**SUBJECT****N20 and N26 Injector Replacement****MODEL**

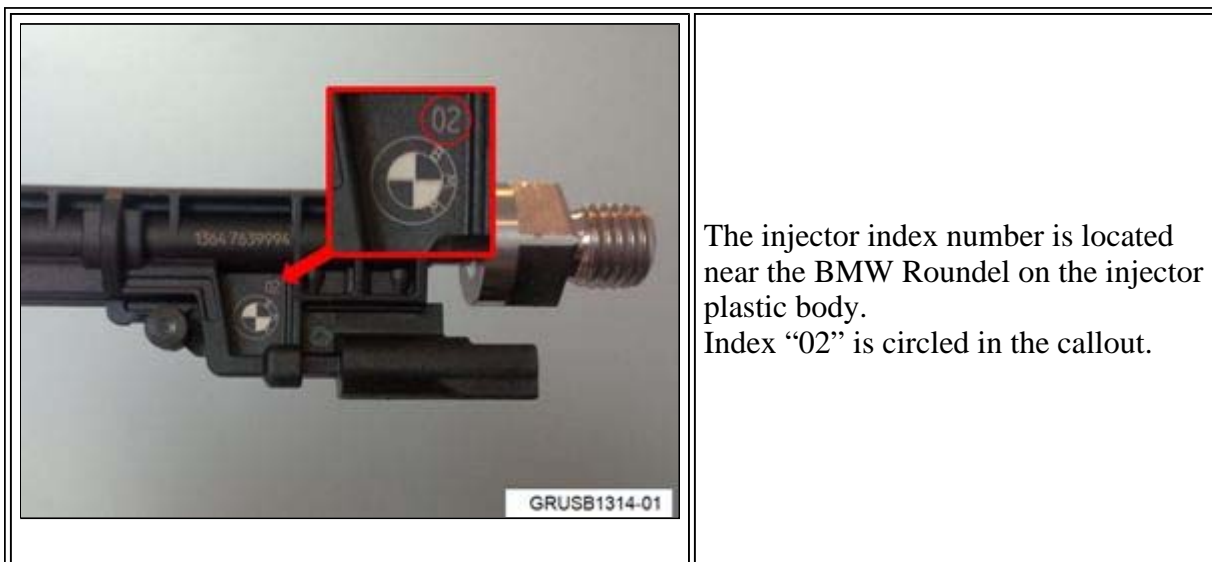
When a defective high-pressure fuel injector is identified with an **index “02”** designation, as shown in the illustration below, **all 4 injectors** must be replaced at the same time.

This bulletin only applies to **index “02”** injectors.

Index “01” and index “03” or higher are not affected.
